From: Maria Tomalova
Sent: 26 January 2022 12:14
To: Chris Moore [REDACTED]
Subject: FW: BR/3/22/DOC

What you provided is not evidently enough for discharging this condition (9)

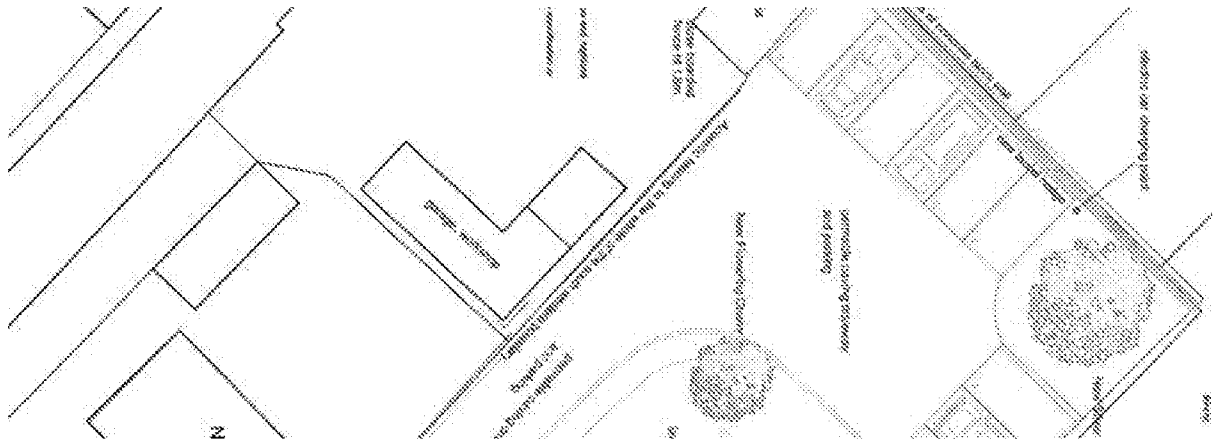
This rather unusual receiving the objection on DOC, however it happens especially if application is allowed on the appeal as the application BR/281/18/PL.
